DOCUMENT CHANGE REQUEST

DCR number 558

Title: Accessories for Connectors Microminiature 3401/029, 3401/077 and Connector Savers 3401/041

Number: 3401/032

Variant 10 - Screwlock Assembly for Connector Savers

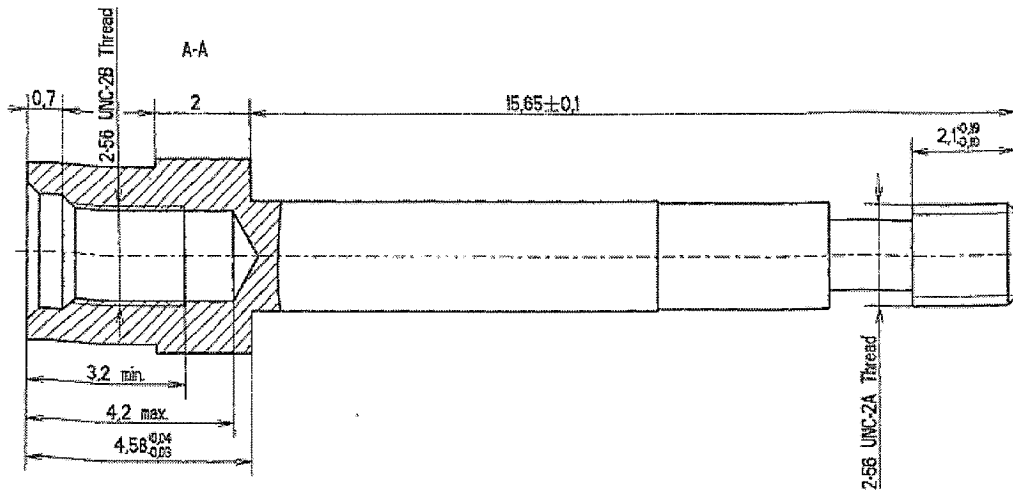
Page 10 : representation of the screwlock to be modified as shown in the attached document.

No word changing, only diameter of the screwlock added on the picture and 2 diameters very similar replaced by a single one.

Current representation with 2 diameters very similar and no value specified is replaced by a single diameter of 2.13 mini.

Design modification and simplification
